RESOLUTION MEPC.52(32)
adopted on 6 March 1992

AMENDMENTS TO THE ANNEX OF THE PROTOCOL OF 1978 RELATING
TO THE INTERNATIONAL CONVENTION FOR THE PREVENTION OF
POLLUTION FROM SHIPS, 1973

(New regulations 13F and 13G and related amendments to Annex I
of MARPOL 73/78)

Figure 1

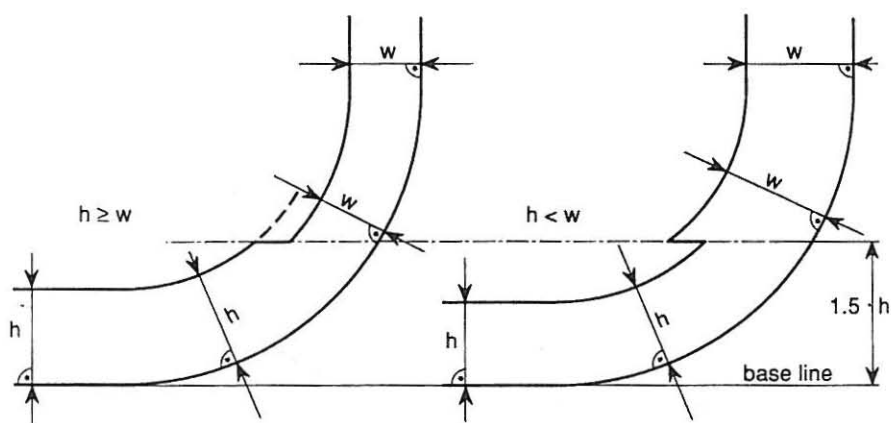
Wing tanks or spaces shall extend either for the full depth of the ship's side or from the top of the double bottom to the uppermost deck, disregarding a rounded gunwale where fitted. They shall be arranged such that the cargo tanks are located inboard of the moulded line of the side shell plating, nowhere less than the distance w which, as shown in figure 1, is measured at any cross-section at right angles to the side shell, as specified below:

At any cross-section the depth of each double bottom tank or space shall be such that the distance h between the bottom of the cargo tanks and the moulded line of the bottom shell plating measured at right angles to the bottom shell plating as shown in figure 1 is not less than specified below:

When the distances h and w are different, the distance w shall have preference at levels exceeding $1.5 h$ above the baseline as shown in figure 1.

$$w = 0.5 + \frac{DW}{20,000} \text{ (m) or}$$

$w = 2.0$ m, whichever is the lesser.

The minimum value of $w = 1.0$ m.

$$h = B/15 \text{ (m) or}$$

$h = 2.0$ m, whichever is the lesser.

The minimum value of $h = 1.0$ m.

Figure 2

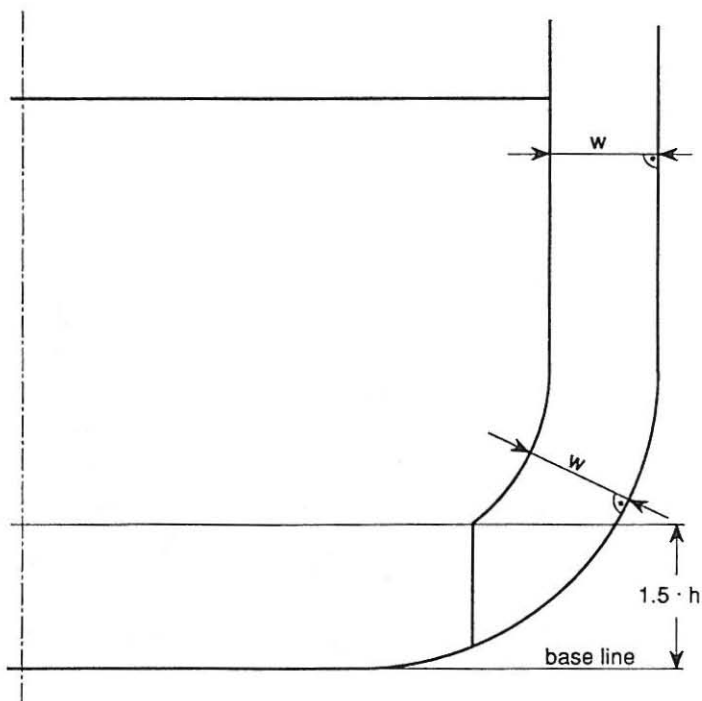
- (4) (a) Double bottom tanks or spaces as required by paragraph (3)(b) may be dispensed with, provided that the design of the tanker is such that the cargo and vapour pressure exerted on the bottom shell plating forming a single boundary between the cargo and the sea does not exceed the external hydrostatic water pressure, as expressed by the following formula:

- (b) Any horizontal partition necessary to fulfil the above requirements shall be located at a height of not less than $B/6$ or 6 metres, whichever is the lesser, but not more than $0.6D$, above the baseline where D is the moulded depth amidships.
- (c) The location of wing tanks or spaces shall be as defined in paragraph (3)(a) except that, below a level $1.5 h$ above the baseline where h is as defined in paragraph (3)(b), the cargo tank boundary line may be vertical down to the bottom plating, as shown in figure 2.

$$f \cdot h_c \cdot \rho_c \cdot g + 100\Delta p \leq d_n \cdot \rho_s \cdot g$$

Figure 3

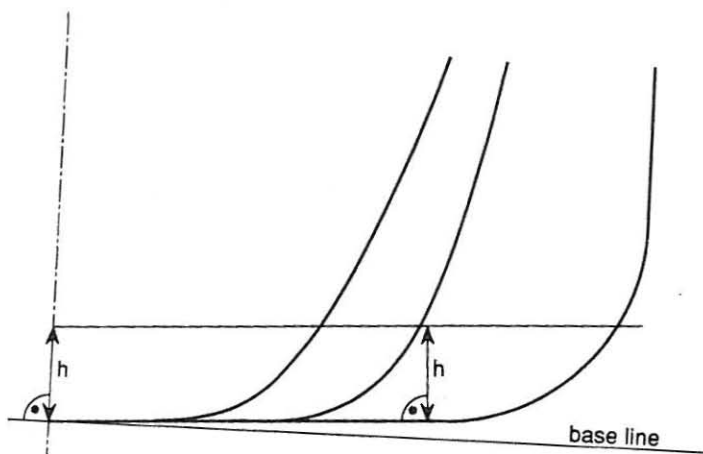
(a) at least be fitted with double bottom tanks or spaces having such a depth that the distance h specified in paragraph (3)(b) complies with the following:

in the turn of the bilge area and at locations without a clearly defined turn of the bilge, the cargo tank boundary line shall run parallel to the line of the mid-ship flat bottom as shown in figure 3; and

$h = B/15$ (m) with a minimum value of $h = 0.76$ m;
